# EXECUTIVE DRIVE BUILDING ADDITION SITE PLAN APPLICATION #07-20

#### STAFF REPORT

**SITE:** 36 Executive Drive; Map 215 Lot 4

**PLANS UNDER REVIEW:** Site Plan - Proposed Building Addition; prepared by Hayner/Swanson, Inc., 3 Congress St., Nashua, NH 03062; prepared for: NV Hudson Industrial, 265 Franklin Street, Suite 1001, Boston, Massachusetts 02110; consisting of 23 Sheets and cover sheet and Notes 1-26 on Sheets 1 & 2; dated June 12, 2020.

DRAWING NAME: 3889-SITE-FQ81 FIELD BOOK: 1239 3889 1 OF 22 DRAWING LOC: J: \3000\3889\DWG\SITE File Number

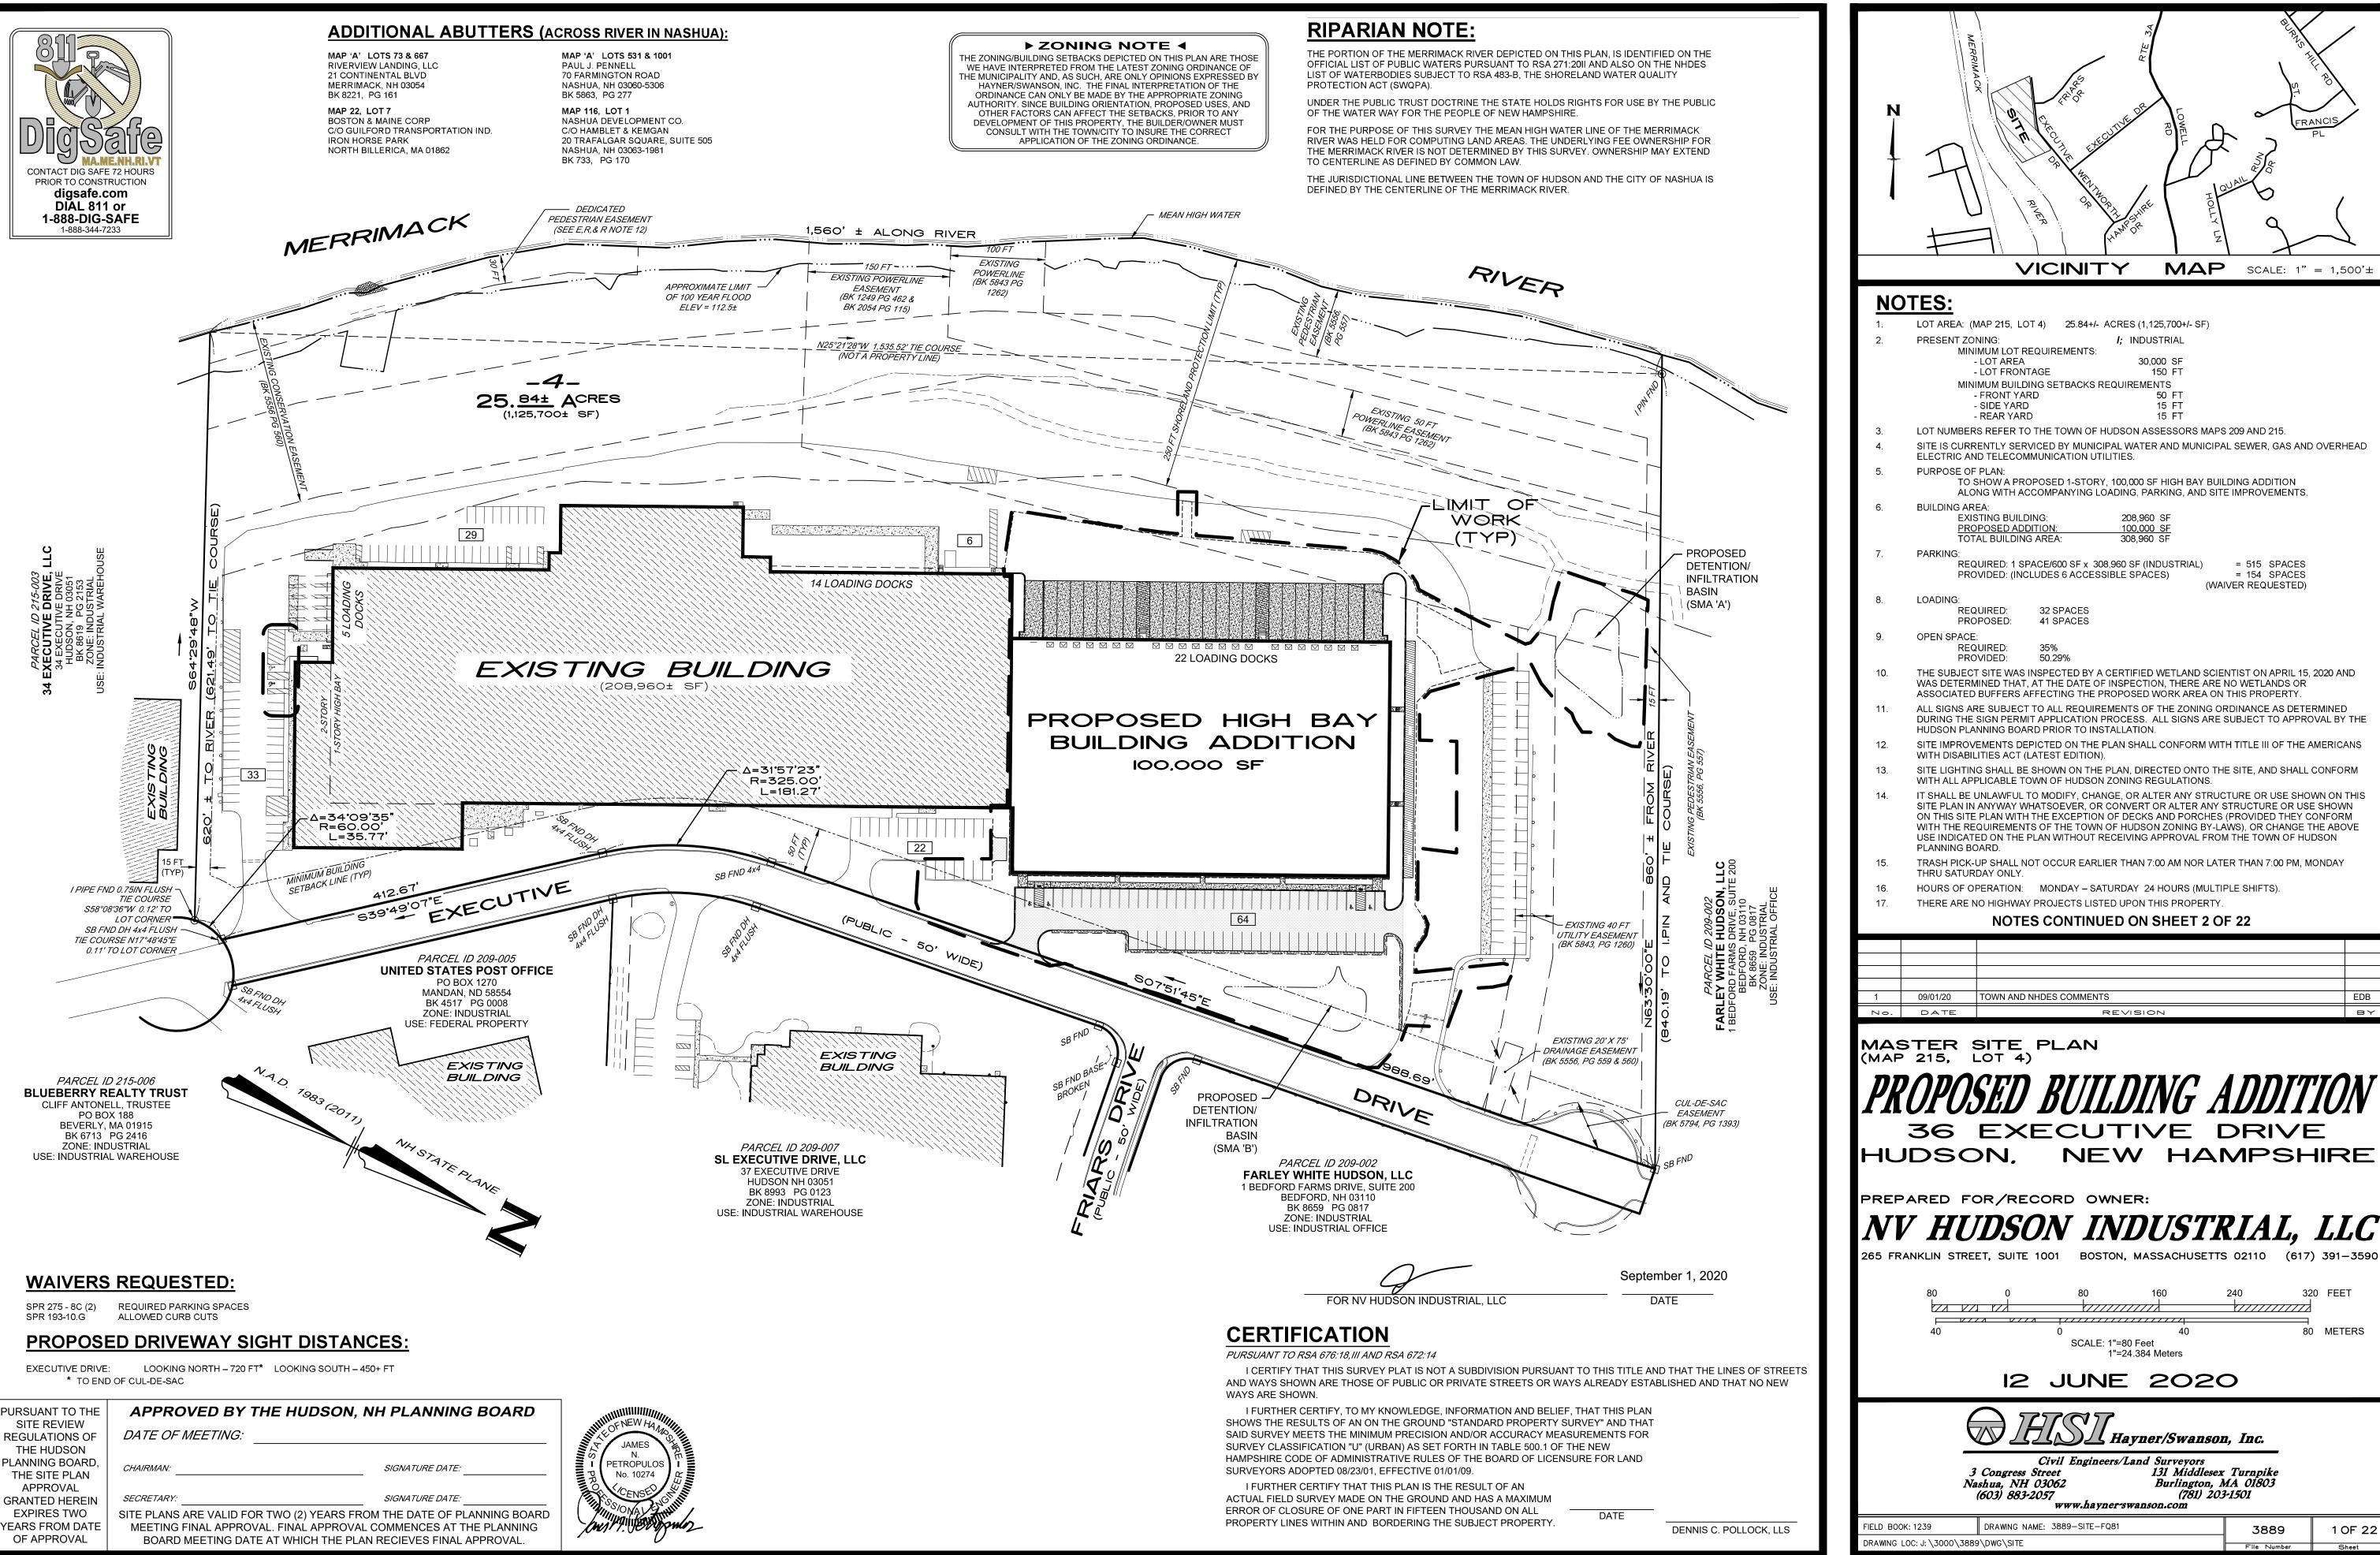
- e. HR 275-8.C.(11). The applicant has stated that 6 handicapped spaces are proposed for the site. We note that only 4 are labeled on the plan set. The applicant should label the 2 existing spaces on the plan set.

FIELD BOOK: 1239
 DRAWING NAME: 3889-SITE-FQ81
 3889
 2 OF 22

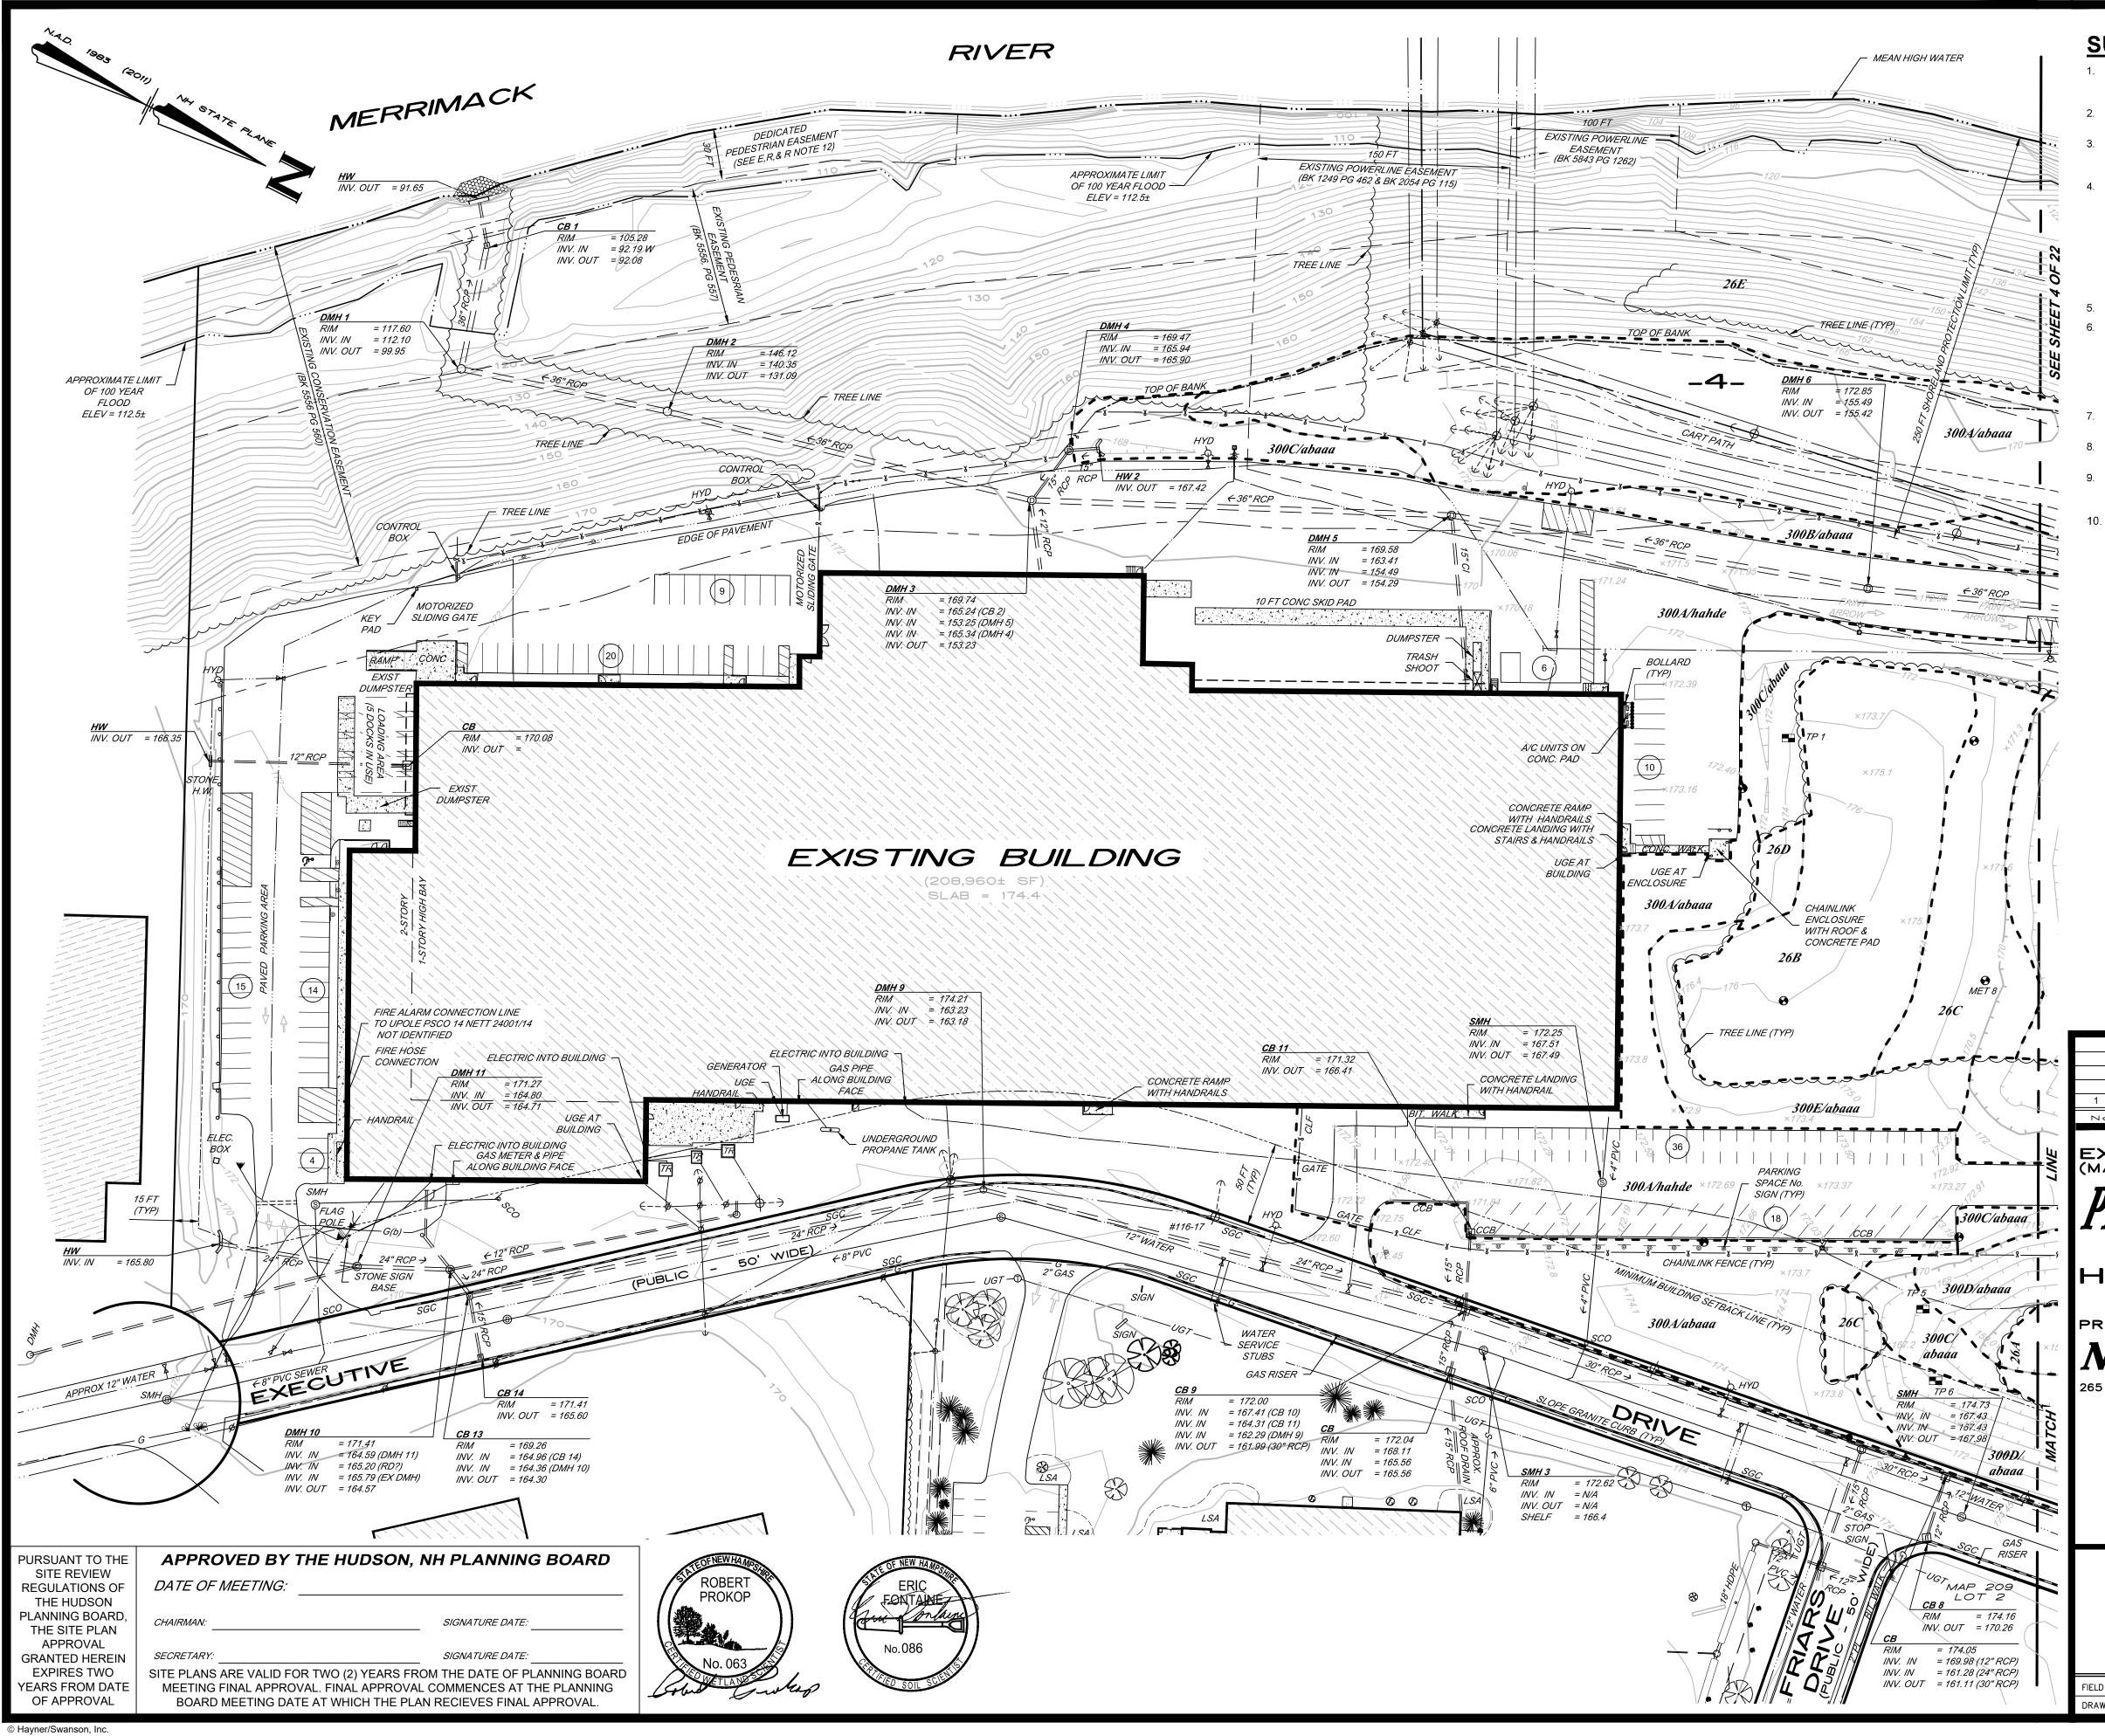
- j. HR 290-7.B.16. The applicant has noted on sheet 2 of 22 that snow removal is to be placed in open areas of the site as shown on sheet 3 of 10. This note should be corrected with the appropriate sheet number reference, and proposed snow storage locations should be shown on the plans.
